Re: Addendum No. 2
Nason Basin to Grove Avenue Storm Sewer Phase 1
City of Willoughby

Date: March 4, 2025

NASON BASIN TO GROVE AVENUE
STORM SEWER IMPROVEMENTS
PHASE 1

12 INCH STORM SEWER & ACCESS ROAD
GRADING PLAN

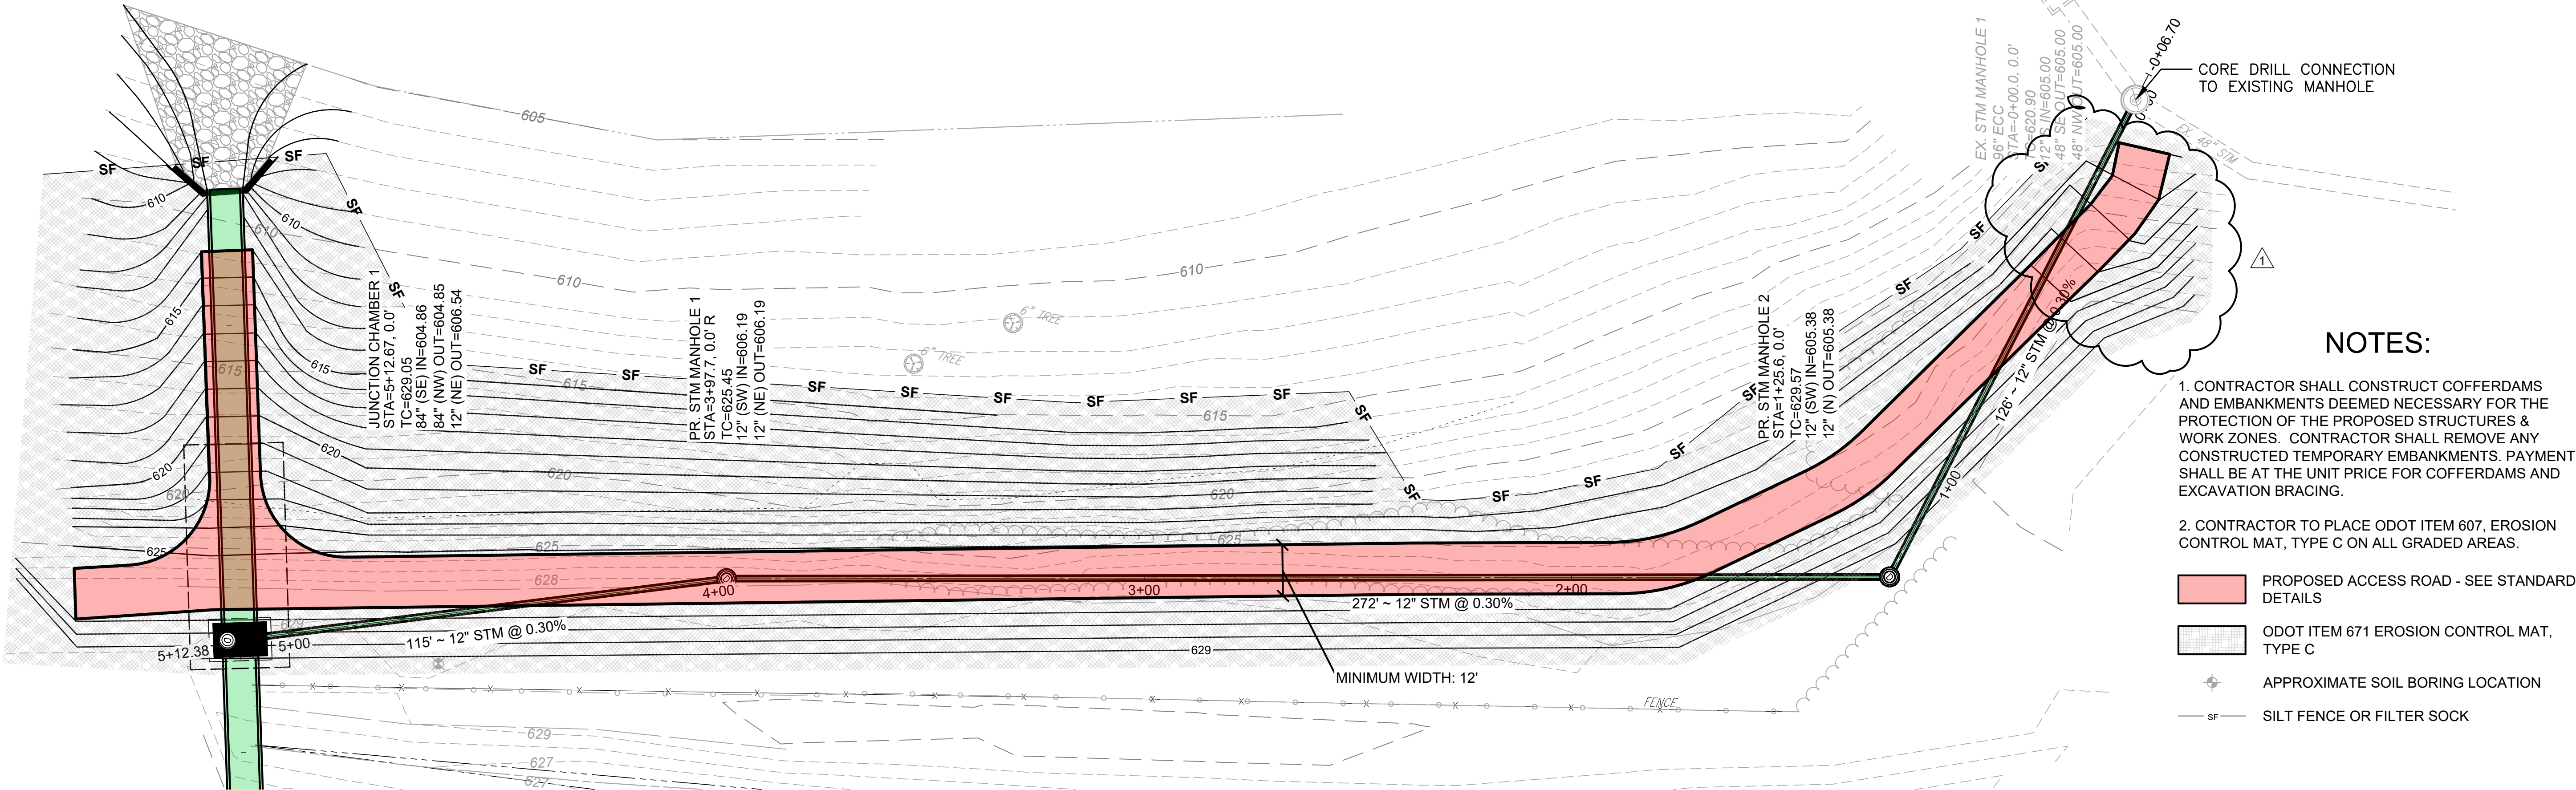
Replace plan sheet 12/43 with the enclosed Revised plan sheet 12/43.
